TECHNICAL SERVICE BULLETIN

No Start/No Crank In Cold Condition

26-2072

27 May 2026

E450762

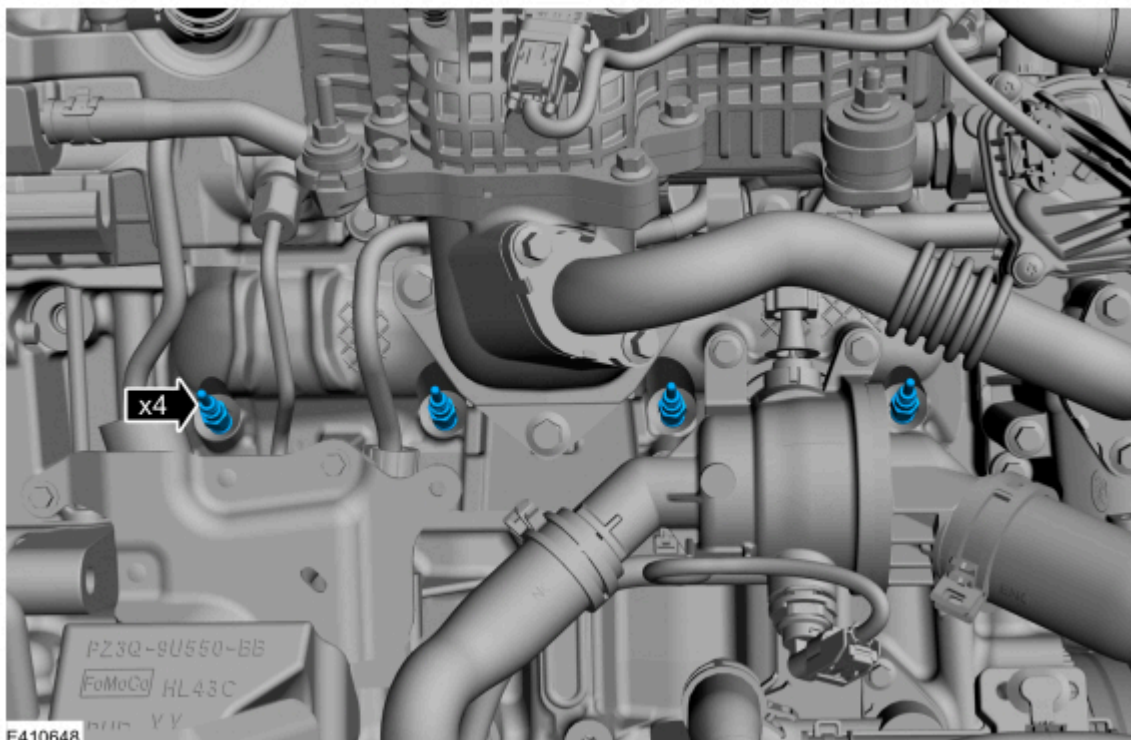
- NOTE: F1 fuse 275 A (PTS Section - Wiring - Cell 011 Page 1 Fuse and Relay Information this is designated as 500 A).**

Check the starter/alternator fuse located in the Auxiliary Battery Fuse Box (275 A) - Installation position: Front left engine compartment next to the front fender splash shield.

- If fuse is OK follow the Diagnosis and Testing procedure for the starter system on PTS.
- If fuse is blown continue with next step. **Don't start the engine.** Do not push the start button before next checks are carried out.

2. Install a new fuse (see Parts Required).
 - Go to next step.
3. Manually rotate the crankshaft two full turns (clockwise) with a ratchet.
 - If not rotating, go to **next step**..
 - If rotating normally, go to **step 6**.
4. Remove the glow plugs and rotate the engine (clockwise) with a ratchet to drain the water from the cylinders. For additional information, refer to 2023 Transit Custom / Tourneo Custom Workshop Manual Section 307-01.
 - Manually rotate the crankshaft two full turns (clockwise) with a ratchet. Afterwards crank engine for approx. five sec.(1-2 times) so that rest of residual condensate water turns out.
